# Technical Bulletin

Model(s)	Year	Eng. Code	Trans. Code	VIN Range From	VIN Range To
Tiguan	2011-2015	All	All	All	All

40 14 04 June 24, 2014 2037509

Clicking or Popping Noise from the Front Suspension after a Change in Direction

Figure 1

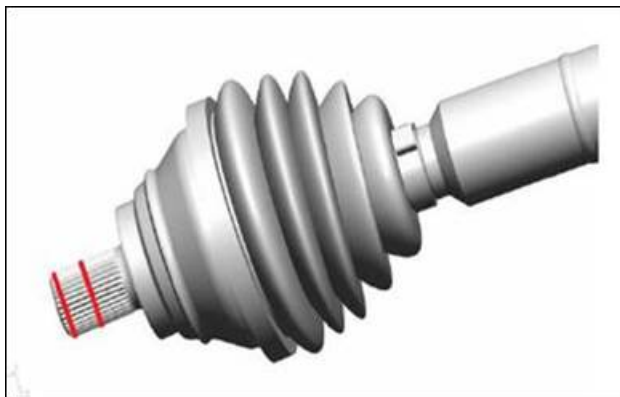
- Remove the drive axle from the affected side following the repair procedure outlined in ELSA Pro.
- Bond the outward splines of the drive axle with liquid locking compound (part number: D 000 600 A2) to the wheel bearings.

Use two continuous beads on the spline. The first bead should be applied at the beginning of the spline and the second should be in the center of the spline teeth (Figure 1, red marks).
